**CITY OF DES MOINES HISTORIC PRESERVATION COMMISSION**  
**STAFF REPORT AND RECOMMENDATION**  
Wednesday, October 19, 2022

**AGENDA ITEM #1**

**CAHP-2022-000095**

**Requested Action:** Installation of a 4-foot-tall black metal fence and gates along the south side and rear yard.

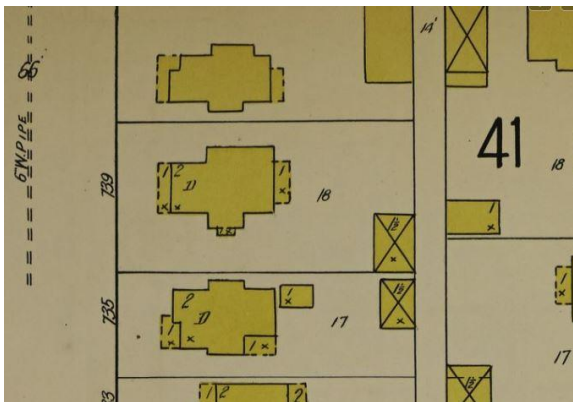
*The applicant is proposing a 4-foot-tall black ornamental steel fence along the south side and rear yards of the property. The fence would begin at the front porch, extend to the south property line, then proceed towards the rear lot line to the back of the garage, where it will turn back towards the north property line and conclude at the rear of the garage. Within that perimeter, the applicant proposes to add two gates – one four-foot-wide single gate along the front, and one 13-foot-double gate along the rear. The applicant submitted example images of the proposed fence that resemble a Montage Classic fence design. Staff is supportive of the request and can review the final design when selected.*

Staff recommends approval of the requested Certificate of Appropriateness subject to obtaining a fence permit with review and approval of the finalized design by the Planning & Urban Design Administrator.

**CAHP-2022-000092**

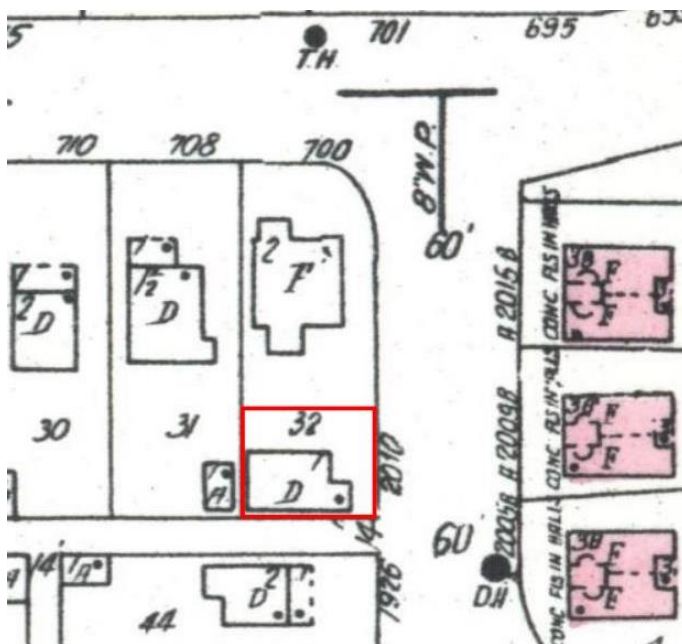
*The property abuts an alley to the south. The house sits near the rear and south property lines. It is not possible to construct a driveway from the alley due to the placement of the house. The applicant is proposing to construct a driveway to the north of the house with a drive approach along 7<sup>th</sup> Street. Staff believes there is no reasonable alternative and supports the request, subject to it being constructed in general conformance with the attached site sketch prepared by staff.*

Staff recommends approval of the request subject to the following conditions:

1. The driveway shall be constructed in conformance with the site sketch prepared by staff.
2. All construction shall be in accordance with all Building and Fire Codes, with issuance of any necessary permit by the City's Permit & Development Center.

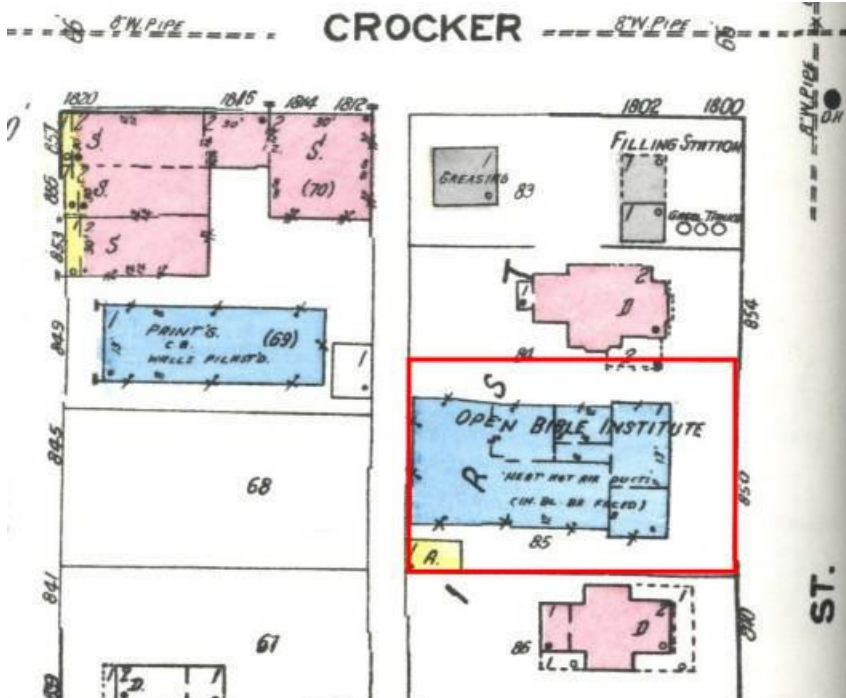
*The applicant has provided two design options for review. Both options propose new windows as previously discussed, as well as reuse of the existing front entrance metal door and sidelite with modifications that include removal of the*

*spandrel glass in the transom windows to be replaced with vision glass and replacement of all dark-tinted glass with clear glass. Option 1 proposes to enlarge the window openings to either side of the front entrance (on the east elevation) and replace the existing window with larger storefront windows. Additionally, Option 1 proposes to create a future tenant entrance on the north elevation that spans the width of (3) existing window openings and replaces them with a storefront system with double door, sidelites and transom windows. Option 2 proposes fewer changes in existing openings, and only proposes that a single window on the north elevation is removed and existing opening increased in size to accommodate a new double door with transom window above to accommodate a future tenant entrance. Staff is supportive of the approach in Option 2 as the new opening is to the side of the building as recommended by the design guidelines and it adheres to the original opening's width. Staff is supportive of the proposal to removal spandrel glass and replace dark-tinted glass with clear glass at the existing front entrance. Both Option 1 and Option 2 propose new lighting above the windows on the north façade which staff supports.*

1. Use of Design Option 2 as presented by the applicant.
2. Unpainted masonry shall not be painted or coated.
3. Site plan compliance is required.
4. Review and approval of any signage by the Planning & Urban Design Administrator.
5. The fence shall be constructed in accordance with a fence permit as issued by the City's Permit and Development Center.
6. All construction shall be in accordance with all Building and Fire Codes, with issuance of any necessary permit by the City's Permit & Development Center.

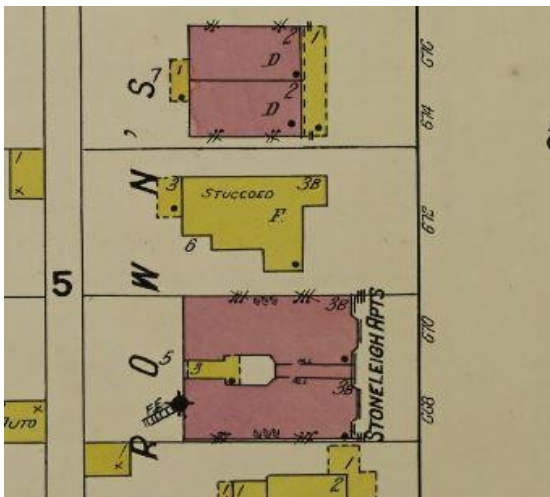
*The applicant is proposing to replace all windows throughout the building, as well as reopen previously closed window openings to install new windows. Marvin wood windows are proposed that would match the existing size of the openings, and match the existing design of the windows as much as possible. At the time of this report, staff and applicant were unable to determine if any of the windows are original to the structure, as staff was unable to schedule a time to tour the building to inspect the windows. Staff is supportive of the new windows for reestablished*

*The applicant is proposing to replace all bulging, deteriorated, and cracking areas on all applicable facades with a new stucco façade material that matches the previous. Applicant intends to have new stucco locations match existing in texture, size, and material as much as possible. Staff supports this request.*

*The applicant is seeking input from the Commission on whether or not to remove the coal chutes on the north side of the building. The applicant originally thought to remove them or cover them up to allow vehicular use of the driveway. However, after some discussion the applicant is considering preservation of the chutes, and removing the driveway instead to return the driveway from the rear façade towards 19<sup>th</sup> Street to open space. While the design guidelines do not outright discuss best practices for preservation or removal of coal chutes, the guidelines do mention that any original door, window, or storm cellar entrances should be retained, and staff believes this provision could also be extended to incorporate any opening original to*

*The applicant is proposing to remove a the chimney on the house. The applicant stated that the location of the chimney negatively impacts the proposed layout of the floors and creates inefficient space. Staff is generally not supportive of the request to remove the chimney, but was unable to determine if the chimney was original to the building or not. If the chimney is determined to not be original or of an age that makes it historically significant in its own right, staff could be supportive of a request to remove. However, at this time staff recommends continuance of this request to allow more time to research and determine the merits of the chimney.*

**CAHP-2022-000099**

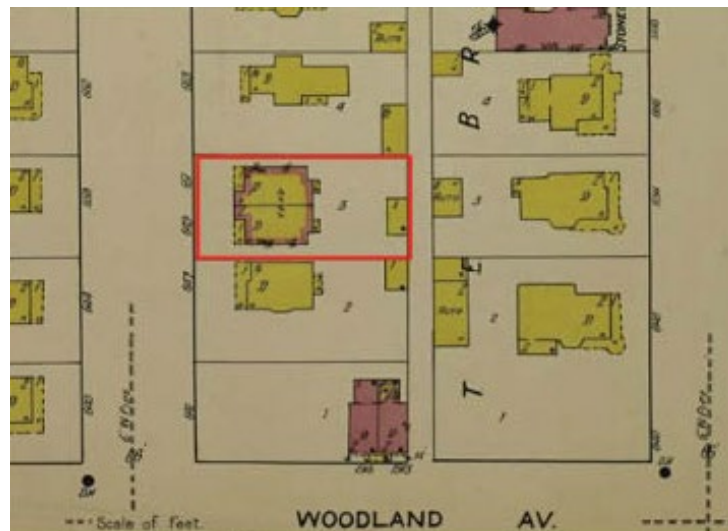
*The applicant is proposing to repoint the brick walls as necessary around the house. The applicant is working with a contractor who has experience working in historic neighborhoods and has completed 5 historic projects previously. The contractor plans to match the existing mortar color and use lime-based mortar. The contractor has identified a few areas where repointing was done poorly with portland cement-based mortar and recommends these areas be scraped and repointed with the appropriate lime-based mortar mix.*
